ARRI TECHNICAL NOTE P-1028

CENTURY PL Mounts on ARRICAM & 435 Advanced
November 15, 2001

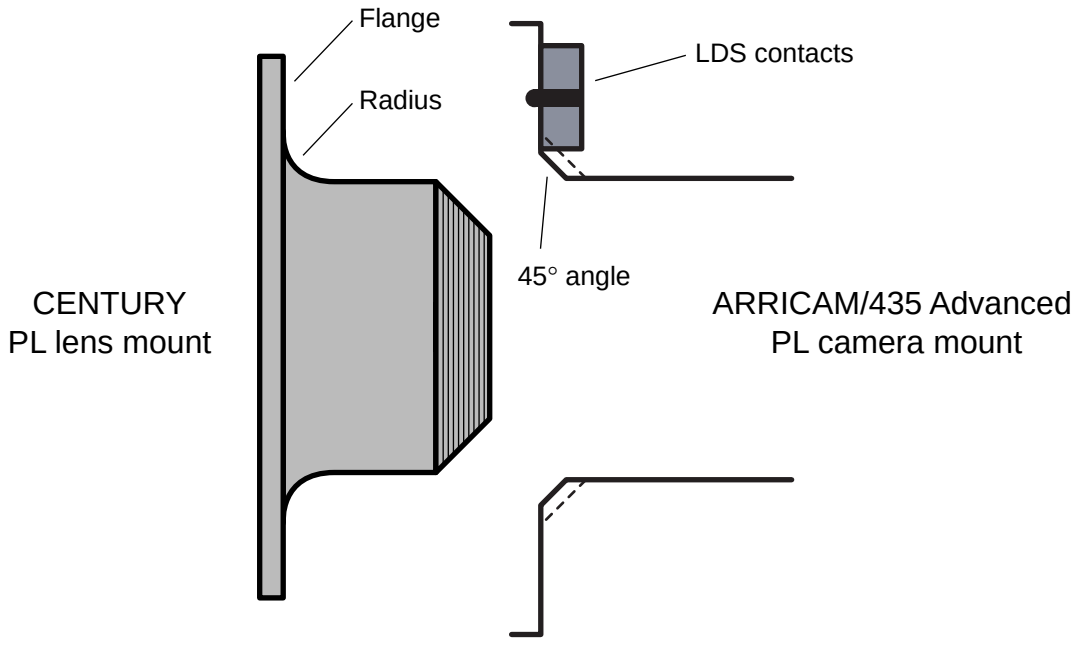
Reason
Unlike Zeiss PL mounts, CENTURY mounts have a slight radius in the 45° angle behind the flange.
On ARRIFLEX cameras this doesn't cause a problem because the 45° angle on the camera PL mount (dashed lines in drawing) is deep enough to accommodate this radius.
On ARRICAM and 435 Advanced cameras this 45° angle had to be moved out to avoid interference with the LDS contacts. This makes it too shallow to accommodate the CENTURY lens mount radius.

Remedy
We recommend to mill down the radius on all CENTURY PL mounts.
